DELEGATED DECISIONS BY CABINET MEMBER FOR TRANSPORT

16 JULY 2026

A361: BETWEEN WILLIAMSCOT & BRADWELL – PROPOSED 40MPH & 50MPH SPEED LIMITS

Report by Director of Environment and Highways

Drawing title
 Plan 1
 Williamscott Hill

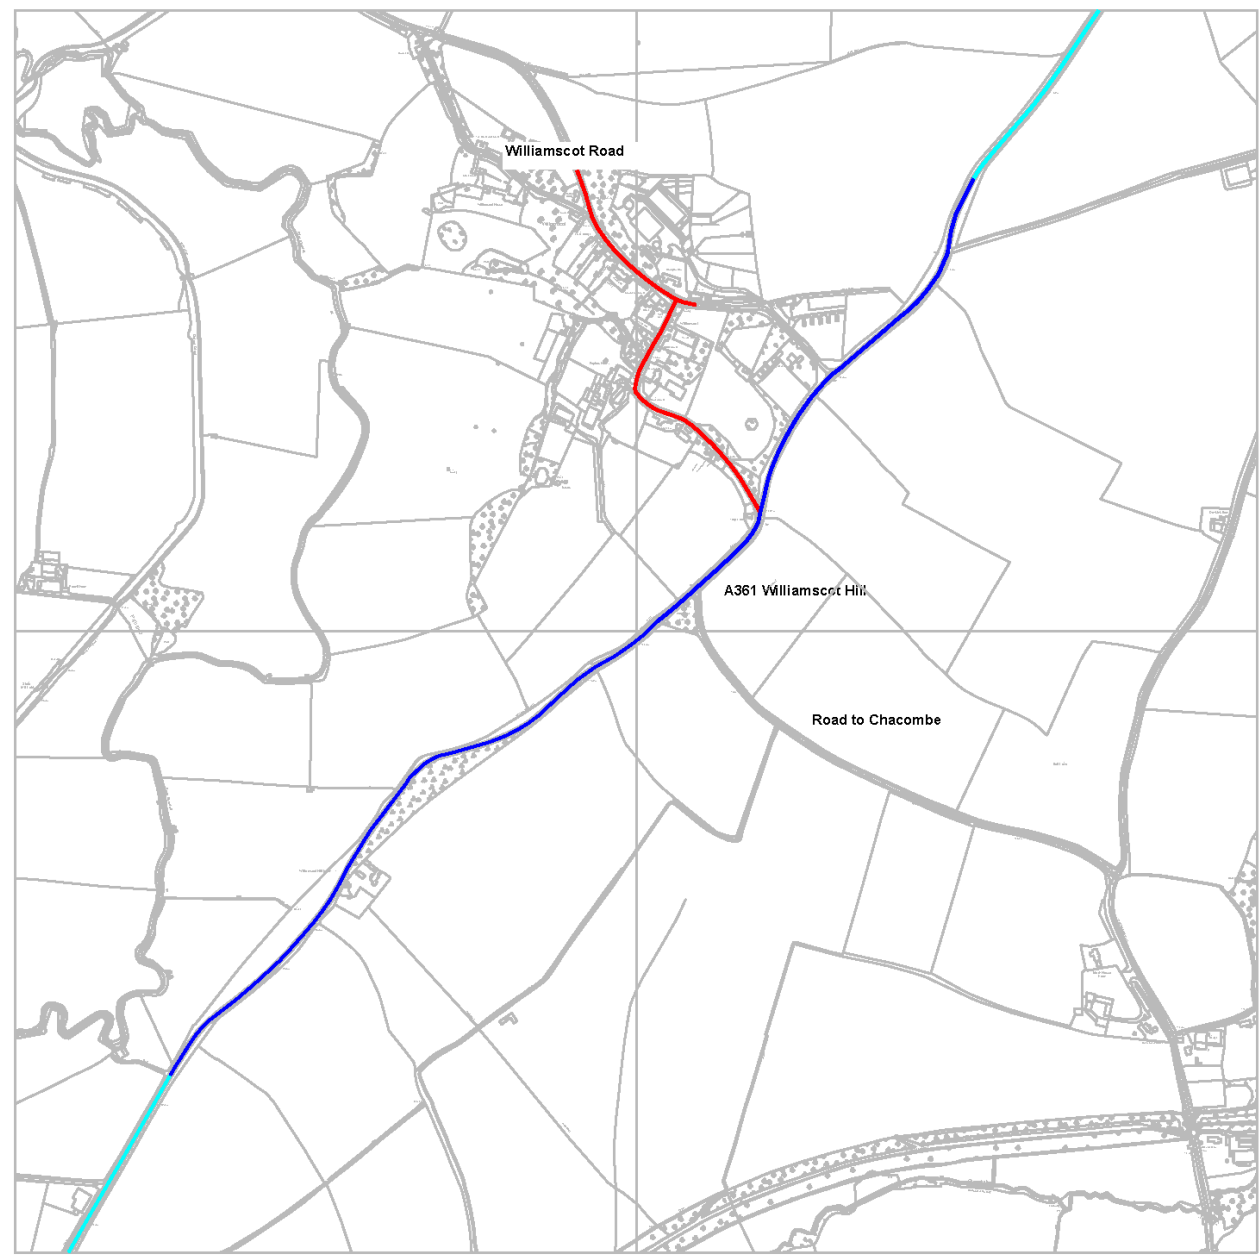
<p>(o3) Local resident, (Bloxham, Carter Drive)</p>	<p>40mph at Williamscot Hill – Object 40mph at Shipton-u-Wychwood –Object 40mph at Bradwell Grove – Object 50mph between Chipping Norton & Ascott-under-Wychwood – Object</p>

Williamscot Hill is a known challenge on the corridor, but 40mph applies a single limit to a road with varied alignment — some sections are considerably more open than the limit implies.

A credible 40mph limit requires either that the road feels like a 40mph road, or continuous, robust enforcement. Neither condition is met — or is likely to be — on a rural A-road in Oxfordshire. The Council should state its enforcement mechanism and baseline compliance estimate for the new limit.

Proposal	Officer comments in respect of compliance with DfT guidance
<p>Williamscot Hill 50mph to 40mph (Annex 1)</p>	<p>The horizontal and vertical alignment of this stretch is poor, with a significant proportion marked with double white centre lines, prohibiting overtaking. Although VAS warning signs have recently been installed at the more hazardous bends, the road is considered to fall into the Table 2 category for 40mph speed limit.</p> <p>This section of the A361 has a poor injury collision history, with 15 casualties (one fatal, four serious and 10 slight) in the five years and three months since January 2021.</p> <p>Actual mean speeds are typically 38 to 44mph.</p>
<p>South of Chipping Norton NSL to 50mph (Annex 2)</p>	<p>This section is considered to have a relatively high number of bends and accesses, so falls into the 50mph Table 2 speed limit category. There have been 28 reported casualties (12 serious and 16 slight) since January 2021.</p> <p>Actual mean speeds are typically 45 to 50mph.</p>

Drawing title
Plan 2 South of Chipping Norton

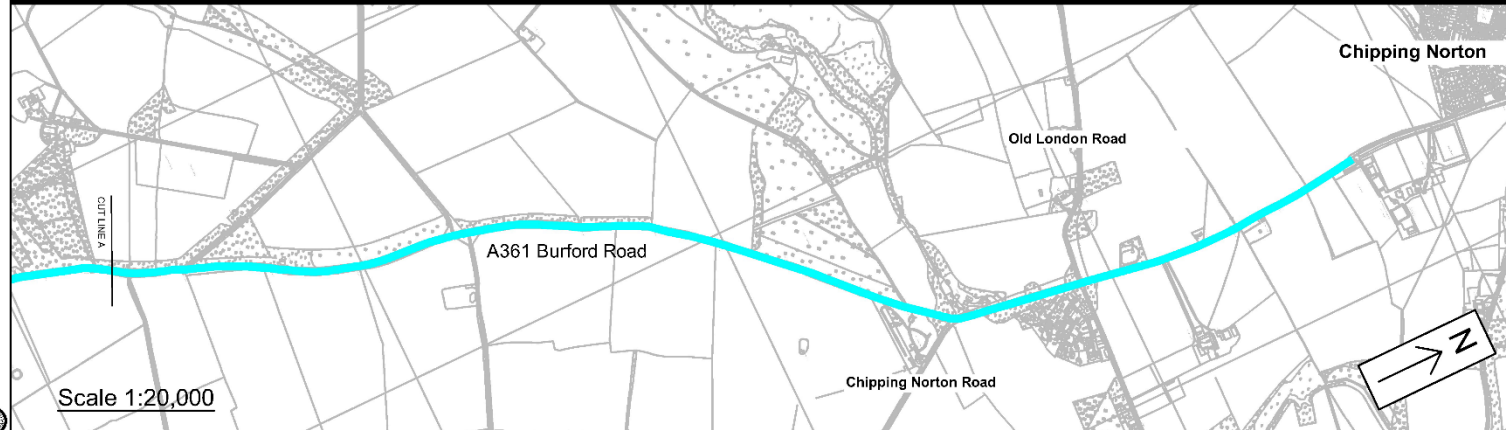
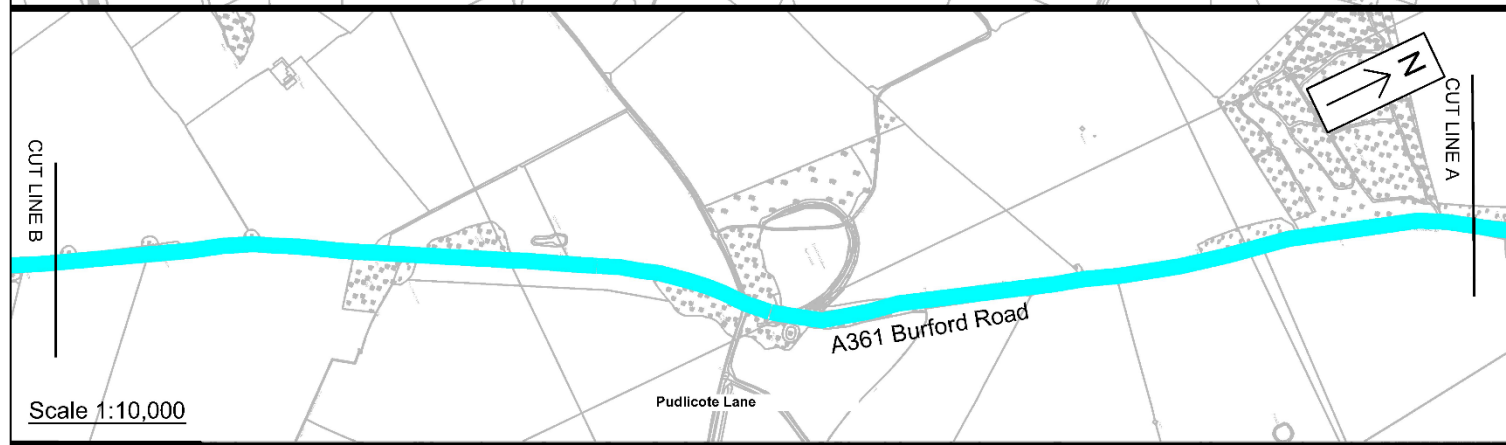
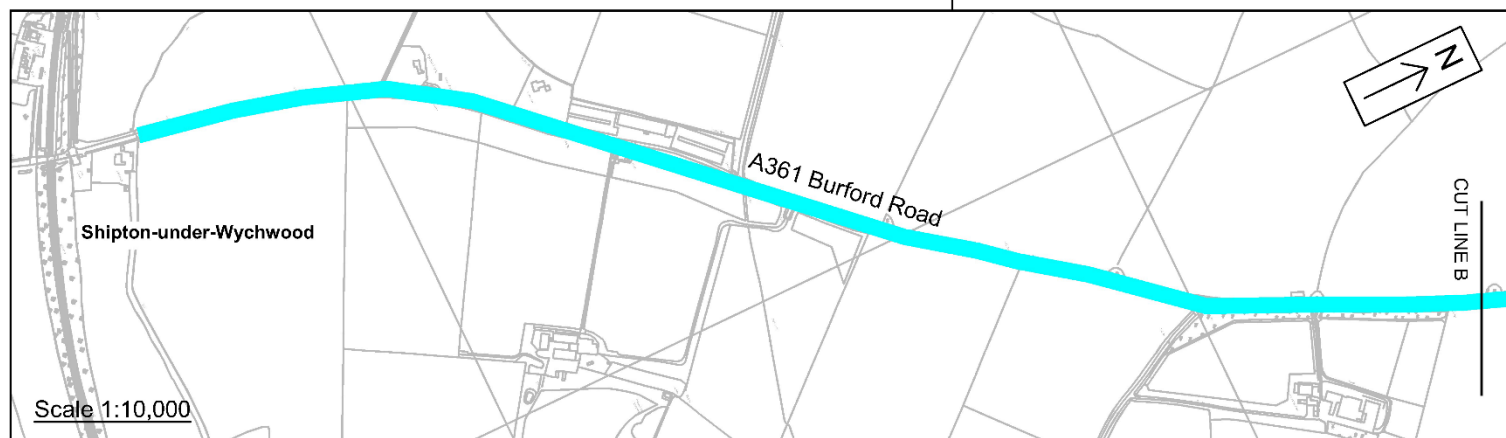
This is the longest proposed change and the one most likely to generate widespread non-compliance.

Between Chipping Norton and Ascott-under-Wychwood, sections with good forward visibility, wide verges, and alignment any reasonable driver would assess as safe at the national limit make a 50mph imposition without physical modification appear arbitrary.

The Council should identify which collision records, sight-line constraints, or surface conditions justify 50mph on each sub-section, rather than apply a single limit across 10 kilometres of varying character. At Swerford, where the road is more constrained, a targeted limit may carry real credibility.

On open, well-aligned sections, a 50mph limit without supporting engineering will generate the frustration and non-compliance described above.

27. Given that the actual mean speeds are at or below the proposed speed limits over the majority of the affected lengths, the new limits will not need to alter the behaviour of most drivers, and while noting the concerns and observations of Stagecoach bus company in respect of any impact on bus journey times, this is very likely to be also true for bus operators.

Drawing title
Plan 3
Shipton-under-Wychwood

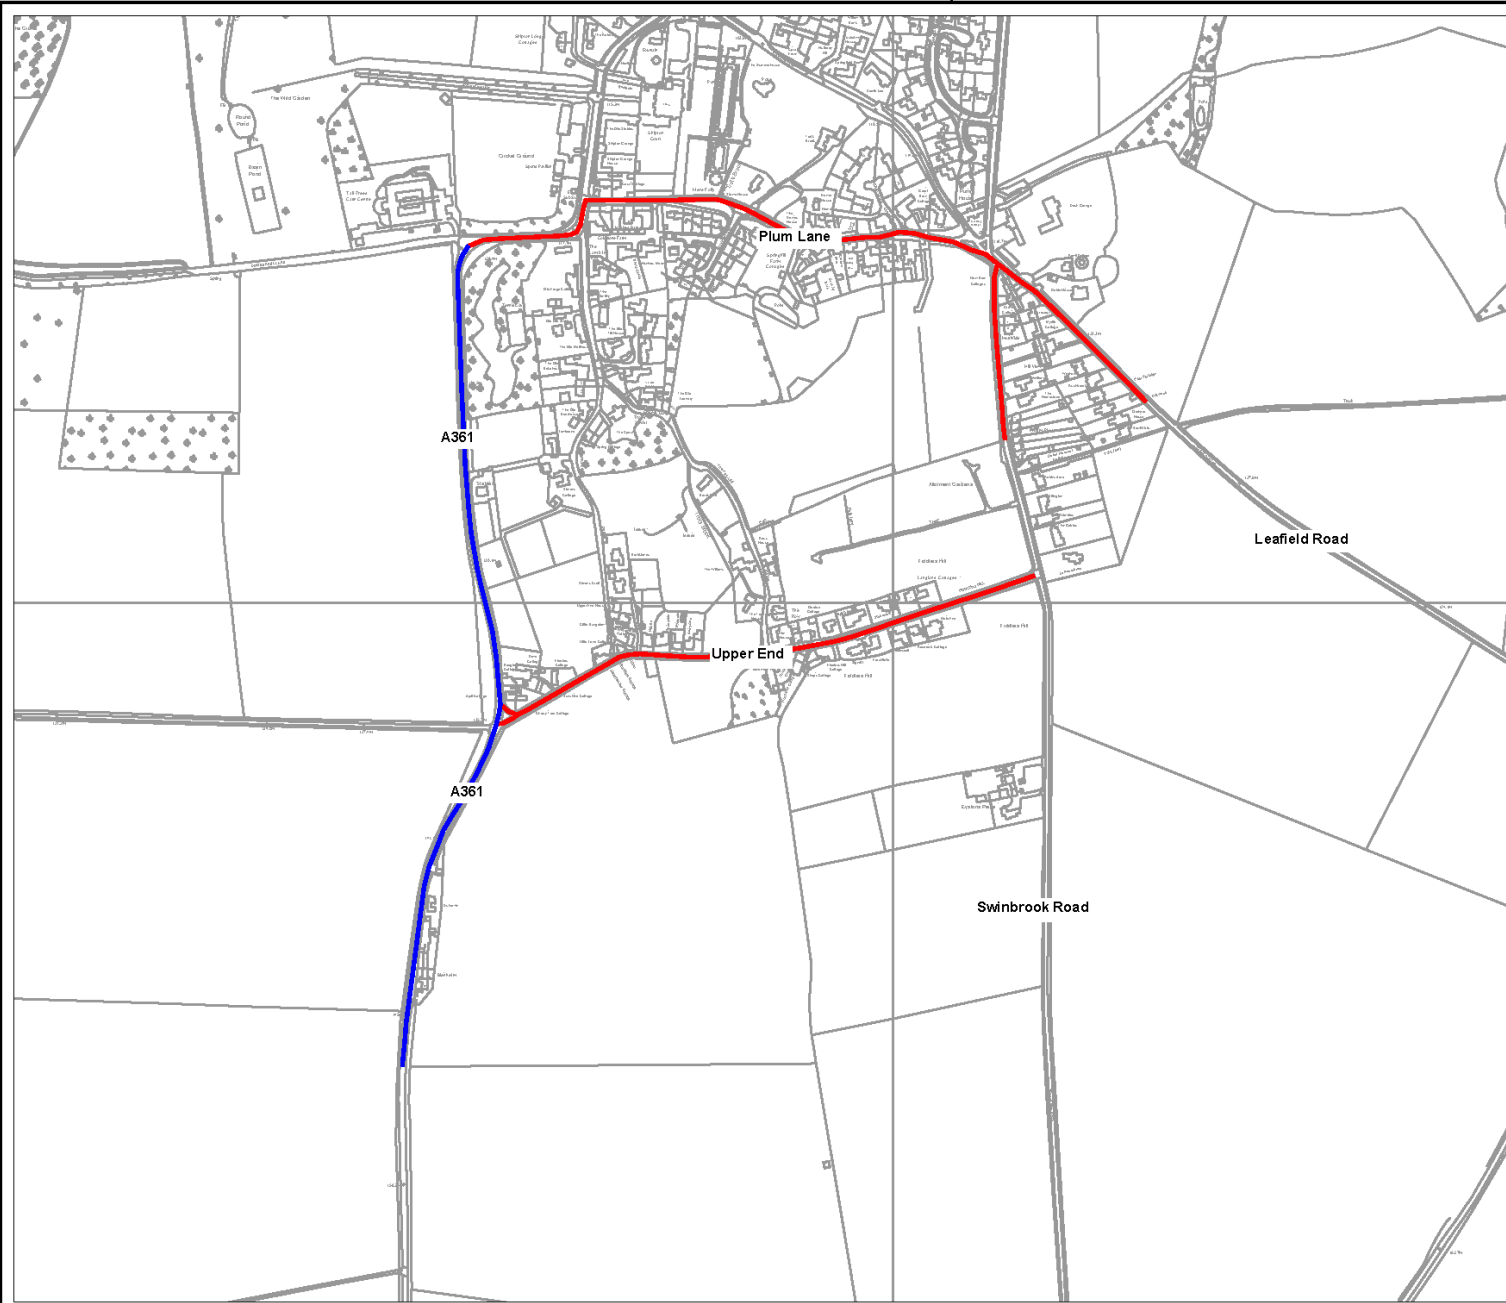
This section adjoins an existing extended 20mph limit at the village boundary — a 20-to-40mph transition is rational at a village exit. The concern is the open road beyond: drivers accelerating away from the village and encountering a 40mph limit where the geometry signals 60mph are likely to accelerate through the zone rather than moderate speed.

Overtaking on exit from a slower zone is a known high-casualty scenario on rural A-roads. The Council should provide collision type data for this location: if rear-end and overtaking incidents dominate, a 40mph limit without physical traffic management will not help and may worsen them. If the casualty record centres on the junction itself, junction treatment addresses the problem more directly than a limit reduction on the approach.

<p>Shipton-under-Wychwood NSL to 40mph (Annex 3)</p>	<p>At present, the National Speed Limit terminates at a right-angled bend where the 20mph limit begins, at the edge of Shipton-under-Wychwood. The proposal would, therefore, provide a buffer between the two limits. The junction with Upper End, and the accesses to properties on either side of this junction, place the length of road within the 40mph Table 2 category.</p> <p>Actual mean speeds vary along the length, being approx. 45mph at the southern end and reducing to approx. 32mph before reaching the village.</p> <p>There have not been any reported injury collisions on this stretch in the period from January 2021, but officers are aware of near-misses reported by residents.</p>
<p>Bradwell 50mph to 40mph (Annex 4)</p>	<p>This length incorporates the junction with Hen N Chick Lane / Hardwick Lane, adjacent to the Cotswold Wildlife Park and Gardens, which has a poor collision history (one serious and three slight collisions/casualties since January 2021). Safety would be improved at this junction if A361 through traffic speeds were to be reduced. There has been one other collision in this section, with three slight casualties.</p> <p>Mean speeds along the length typically increase from approx. 40mph at the northern end to approx. 45mph to the south. It is considered that the nature of the section, particularly at the northern end, places it in the 40mph Table 2 category. It is appropriate to change the full length of the 50mph limit (1.65km) to 40mph, rather than changing part of the length and introducing another terminal point.</p>

Drawing title
**Plan 4
 Bradwell**

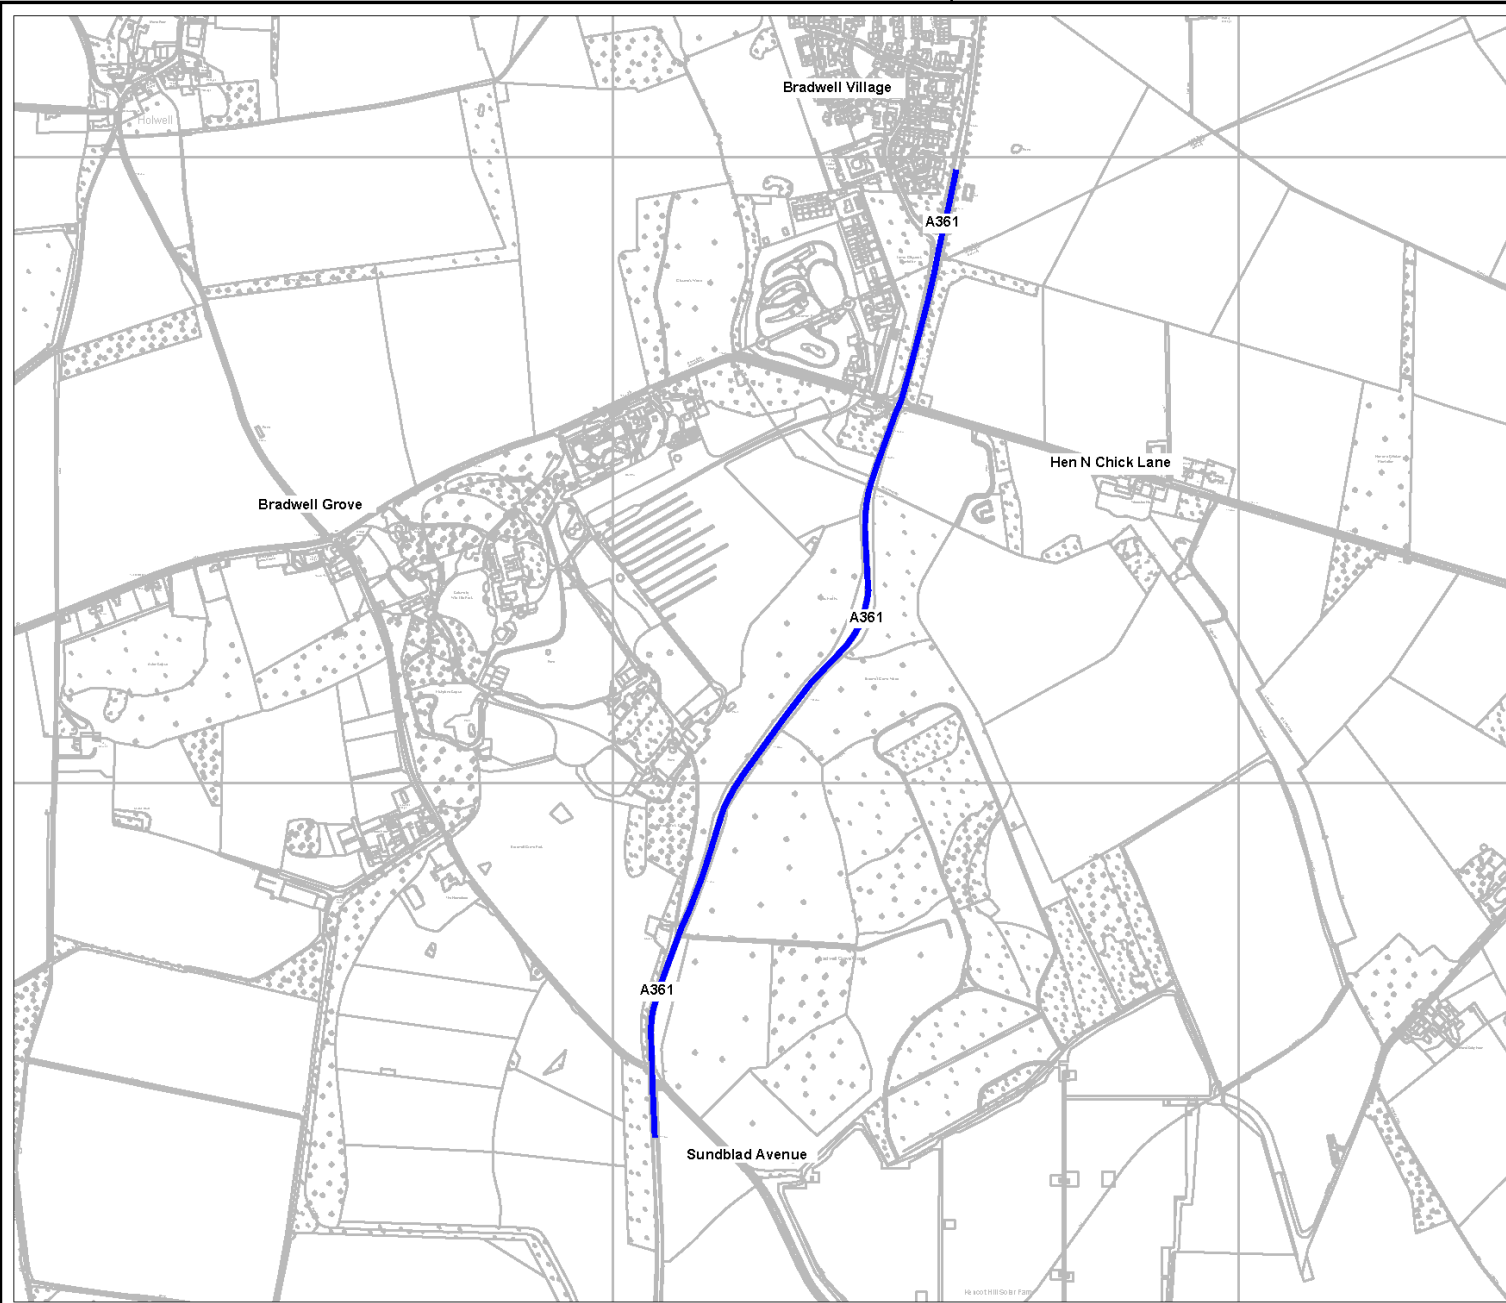
Bradwell Grove is the site of a recorded fatal collision, but causation is the critical question. If the collisions involve vehicles leaving the carriageway on bends, or junction conflicts at the Bradwell Grove access, the response should be engineering — improved delineation, junction geometry review, surface treatment, or bend warning systems. A 40mph limit does not address departure angle, friction coefficients, or junction sight distances.

If overtaking on the approaches caused the collisions, the current limit may already be too low for the road alignment.

Q3. For the fatal collision at Bradwell Grove, what was the causation finding, and how does a 40mph limit directly address it?

28. The primary intention is to reduce the speeds of the fastest vehicles; those which are more likely to be involved in a collision than the slower vehicles. VAS bend warning signs have been placed at specific high-risk bends at Williamscot Hill, and improved signage is planned for the Hen N Chick Lane junction, but further VAS or engineering measures are not considered to be cost-effective or appropriate along the rest of the route.
